Computer listing information was primarily used to define those portions of problem 6-4, 6-7 beyond the scope of this study (Reactor System Primary Piping). However, it was also used if the desired information was not defined in the information package or that definition was inconsistent with other data or dimensions.

As per the discussions with Jim Knight on February 15, 1983, pertaining to the analysis to be performed for these piping systems, BNL has now satisfied the requirements for confirmatory analysis of these piping problems (i.e., Task 2, problems 3 and 4, FIN No. A-3357). If you want us to expand the verification efforts for these problems, please advise us thereof.

Problem 6-4, 6-7 Comments

Problems 8-118 Comments

PROBLEM 8-118

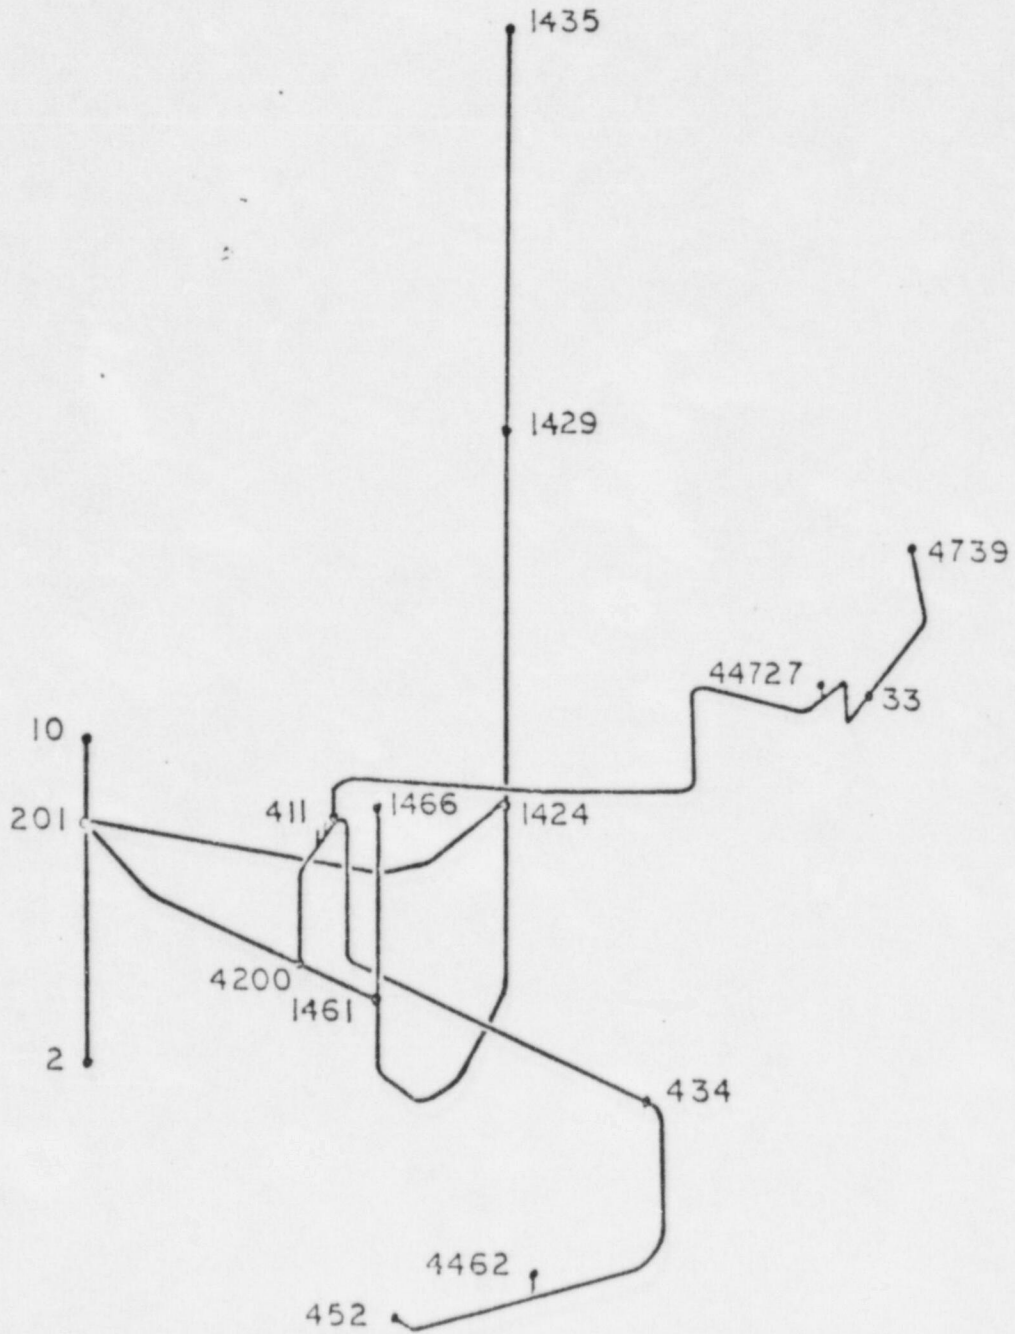
1. Node labels taken identical to PG&E's labels.
2. Five nodes (98, 117, 245, 270 and 442) added to reduce span lengths.
3. All dimensions from PG&E DWG's 446540, Rev. 11 and 447117, Rev. 6.
4. Span length difference of 3' noted between nodes 85 and 95 (BNL span larger).
5. Span length differences of the order of 0.3' noted in vicinity of nodes 85, 125, 205 and 270 (BNL spans larger).
6. The X coordinates of nodes 90 and 93, supports 98/4R and 55S/162R, undefined. PG&E computer listing used.
7. Support 55S/162R not shown.
